**HILLSBOROUGH COUNTY
SOUTHEAST COUNTY LANDFILL
CAPACITY EXPANSION, SECTION 8
CERTIFICATION OF CONSTRUCTION
COMPLETION REPORT
RESPONSE TO DEP REQUEST FOR
ADDITIONAL INFORMATION**

Subject: Response to Request for Additional Information
Southeast County Landfill, Hillsborough County
Capacity Expansion Section 8
Certification of Construction Completion
Permit No. 35453-009-SC
Jones Edmunds Project No. 08449-020-01

**HILLSBOROUGH COUNTY
SOUTHEAST COUNTY LANDFILL
CAPACITY EXPANSION, SECTION 8 CLASS I LANDFILL
CERTIFICATION OF CONSTRUCTION COMPLETION REPORT
RESPONSE TO DEP RAI**

ATTACHMENT R26
REVISED DRAWINGS – SHEETS 5 AND 8

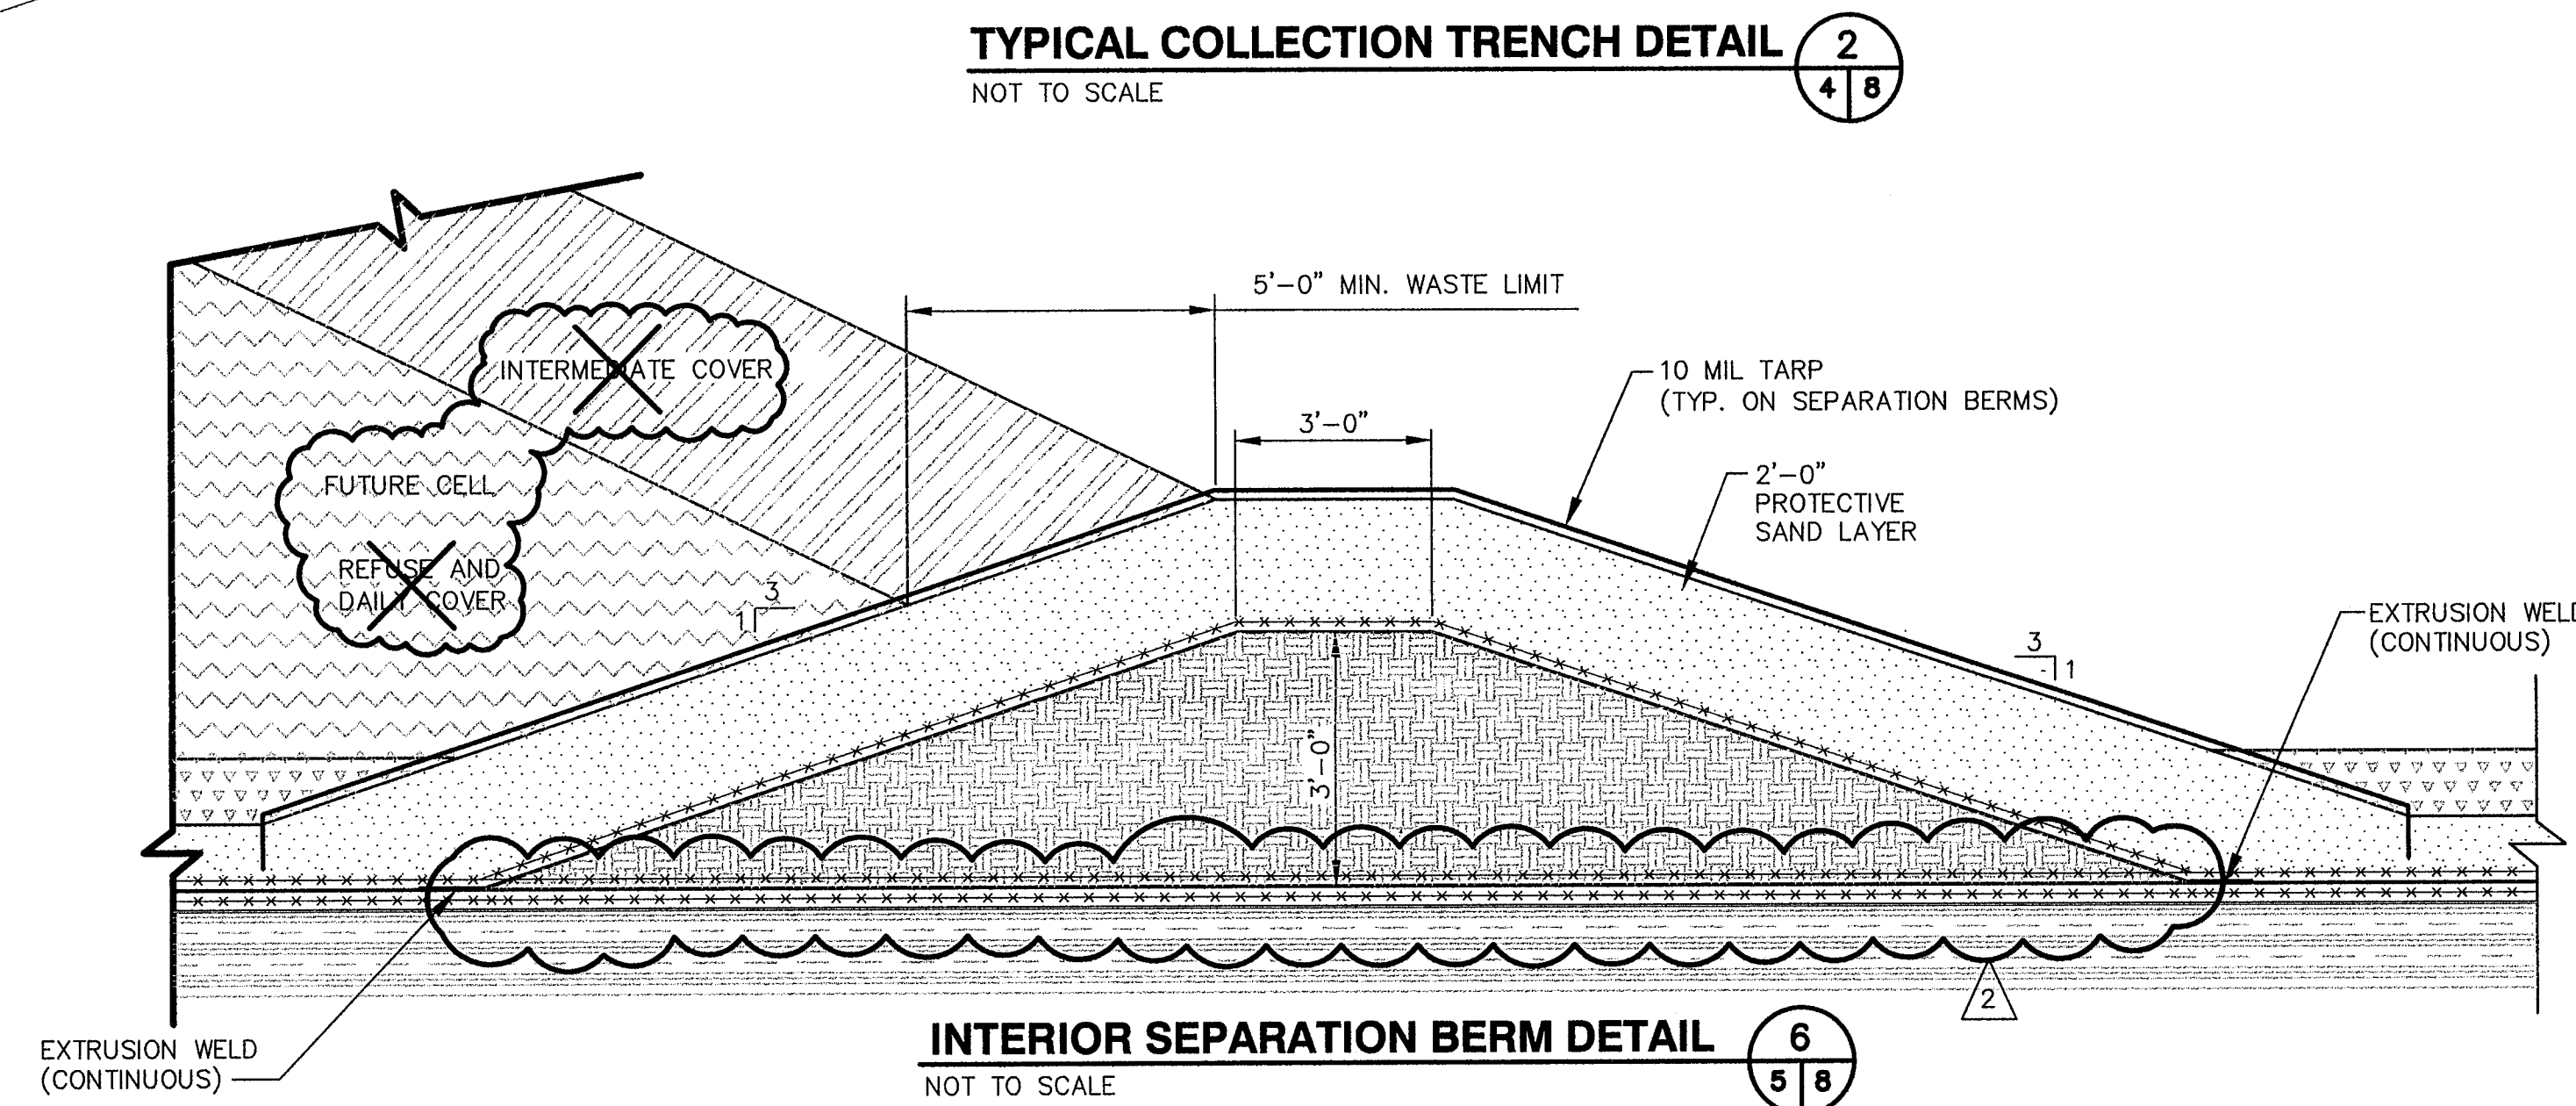
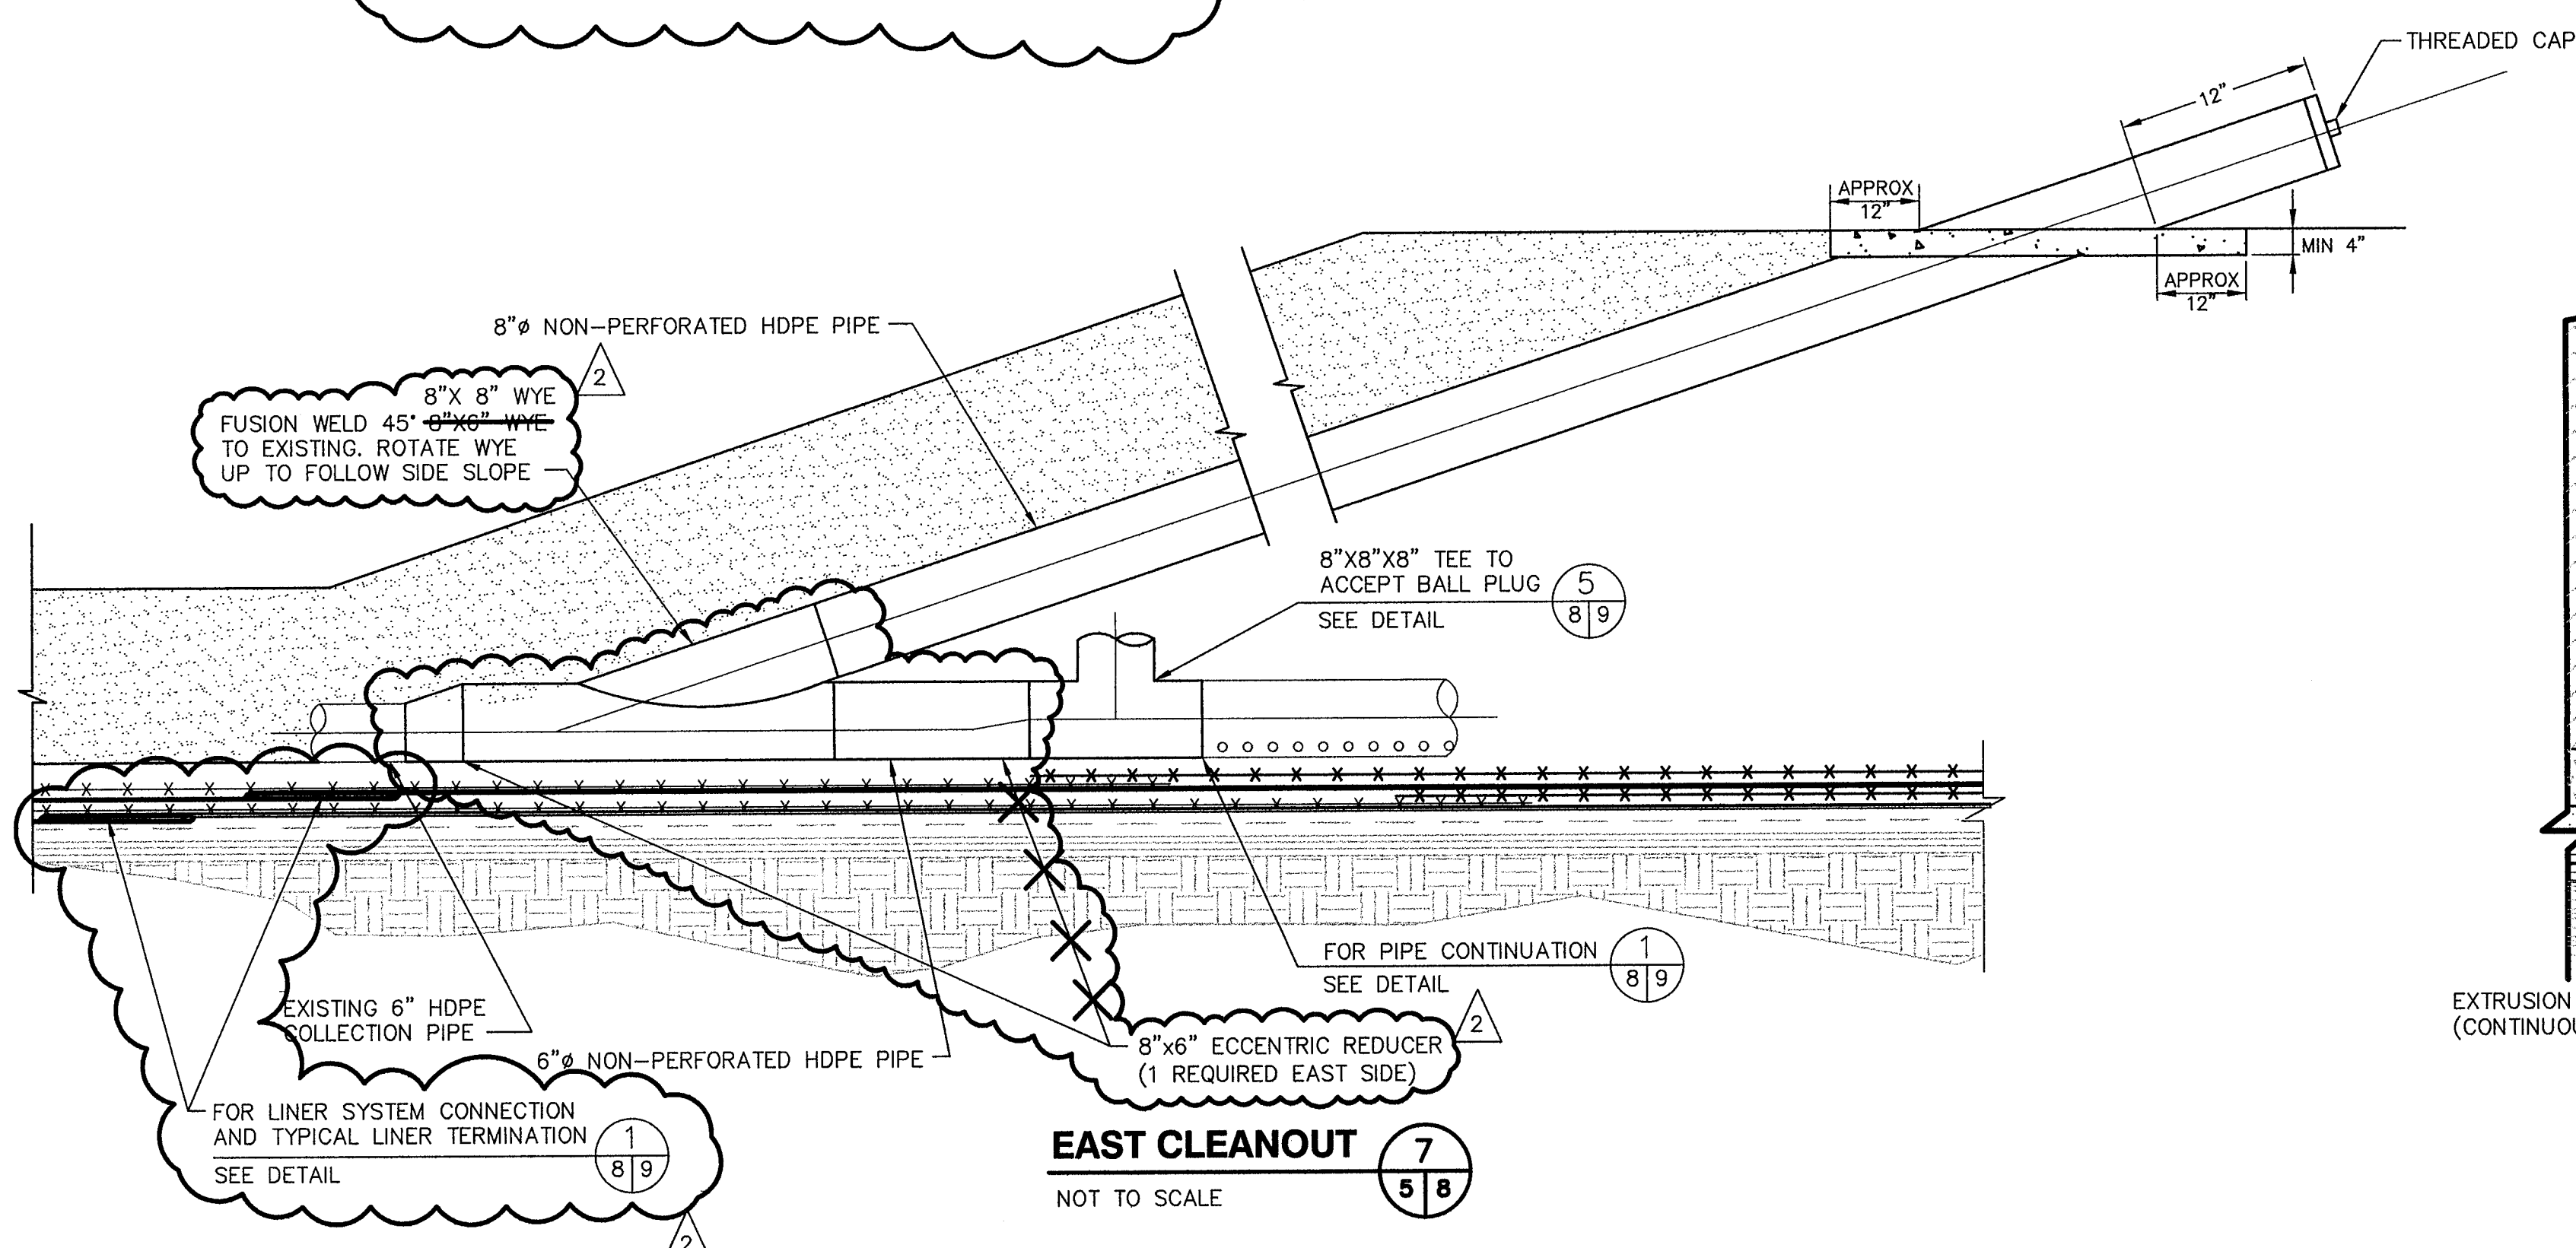
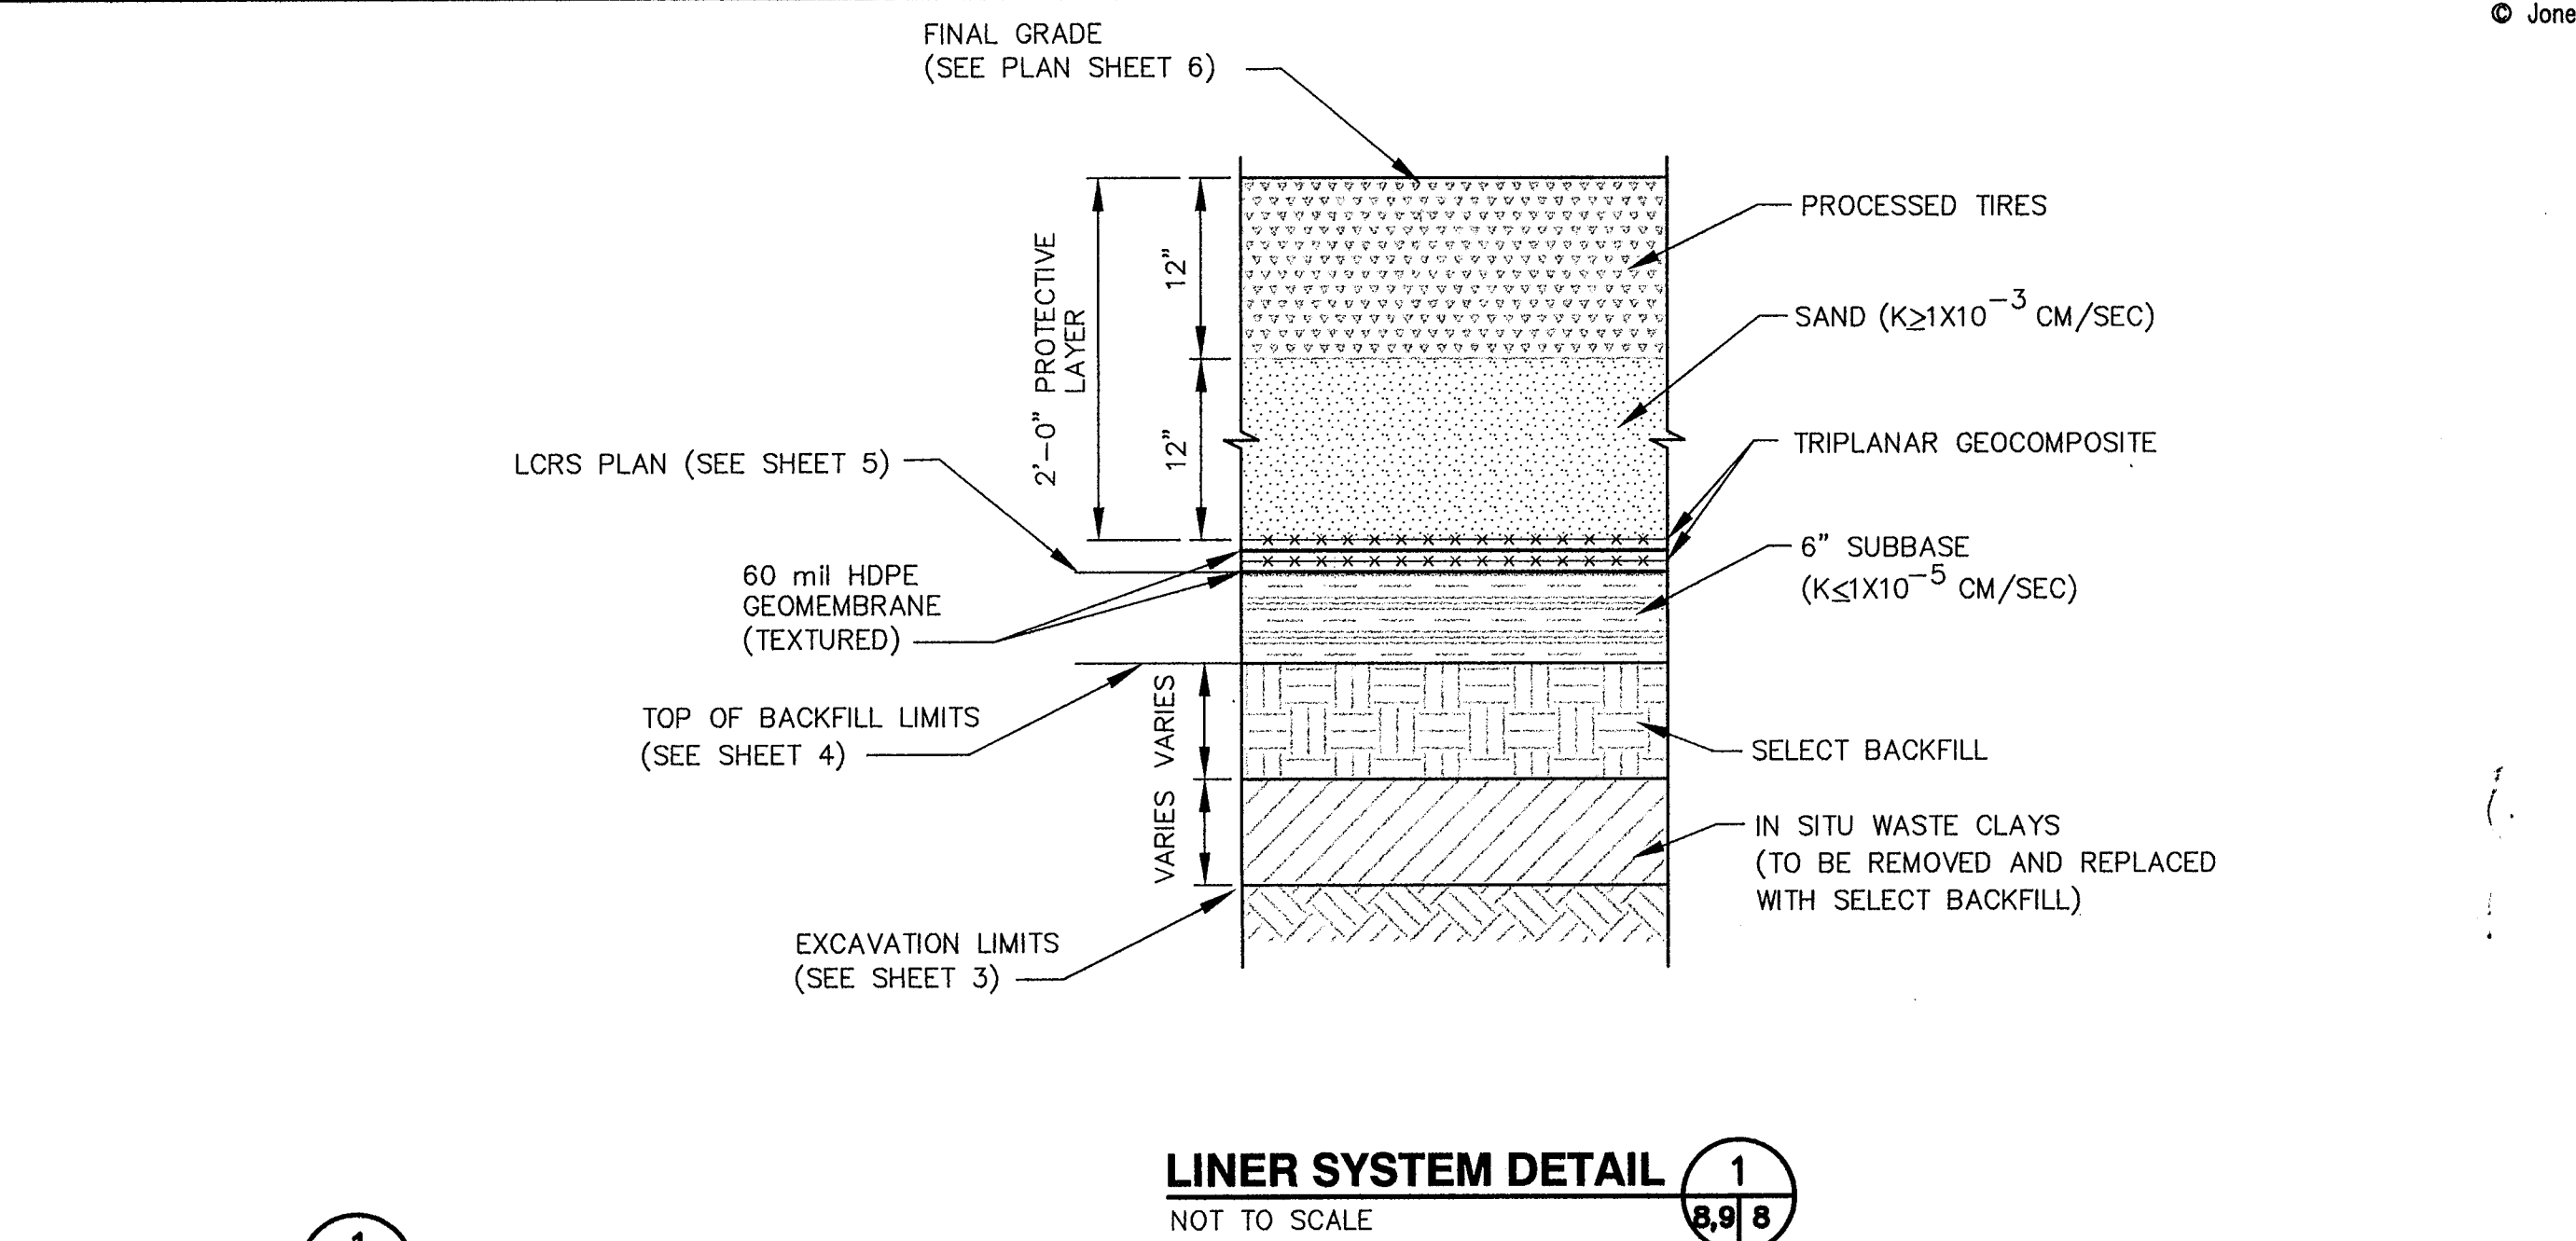
Comment 23: Sheet 5. Please specify the changes in Details 5/8 and 6/8.

Comment 26: Sheet 8. Please verify the detail number for the separation berm detail. It appears that there are two Detail 6 on this sheet.

Response 23: Detail 5/8 provides for the gravel pack around the eastern-most leachate collection, at the toe of the east side slope. The previous design for the gravel pack around the leachate collection pipe did not account for the pipe to be located near the toe of slope. The intent of the design was not altered.

Detail 6/8 provides for a slight change in the configuration of the reducer and wye to account for existing conditions. The intent of the design was not altered.

Response 26: There are two Details 6 on this sheet. Revised sheets 5 and 8 with the corrected detail references are provided in Attachment R26.
